**UNITED
TECHNOLOGIES
CARRIER**

BULLETIN: CA-SB-19-E-78-91
DATE: 4/4/75
PAGE: 1 OF: 3

19 SERIES HIGH VOLTAGE TERMINAL THREAD SEALING

PURPOSE: To provide information necessary to distinguish differences in styles of hi and lo voltage terminals.

Fig. 1, 2, 3

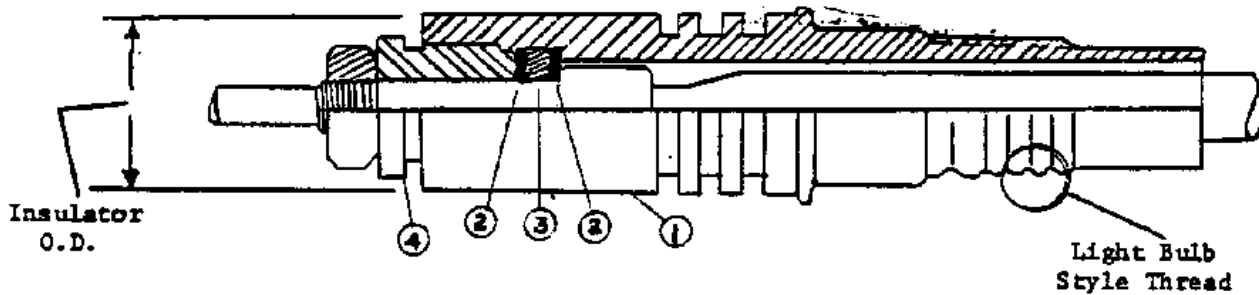
Figure	Description		Used On	If Service is Required
1.	H	Design 1 - Rigid. Terminal with 1" NPT.	19EA machines shipped before 5/3/71.	Parts no longer available. Change to Design 3.
2.	I V O	Design 2 - Rigid terminal with 1" light bulb thread. Insulator O.D. - 1.62" Textolite terminal board.	Machines shipped from 5/3/71 (approximate comp. s/n 100434) to 3/74.	Parts are still available. Can be converted to Design 3 for greater strength and leak integrity.
3.	L T	Design 3 - Rigid terminal with 1-1/4" light bulb thread. Insulator O.D. - 1.88" molded black phenolic terminal board.	Machines shipped after 3/74.	Use Design 3.
4.	L O V	Design 1 - Flat Textolite terminal board.	Machines shipped prior to 3/74.	Parts are no longer available, change to Design 2.
5.	O L T	Design 2 - Molded black phenolic terminal board.	Machines shipped after 3/74 (approximate).	Use Design 2.

Fig. 4

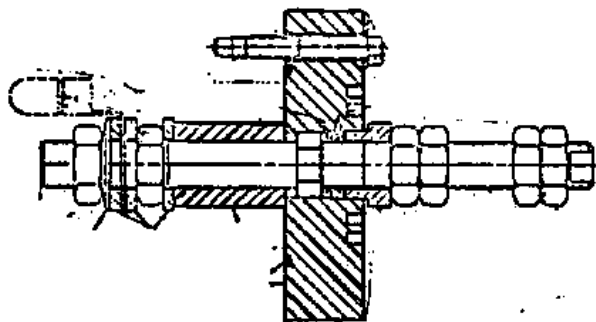
Tighten this nut sufficiently to completely flatten Belleville Washer (Item 3).

Fig. 5

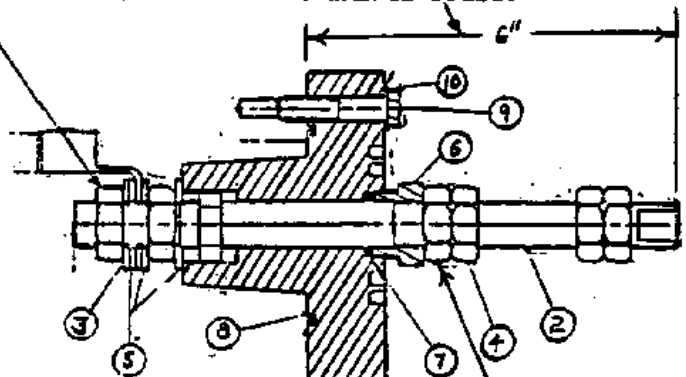
This dimension to be checked at assembly. A dimension less than 6.00 indicates hex is not properly engaged into socket in terminal board.

Tighten to prevent refrigerant leakage 120 lb-in. max.
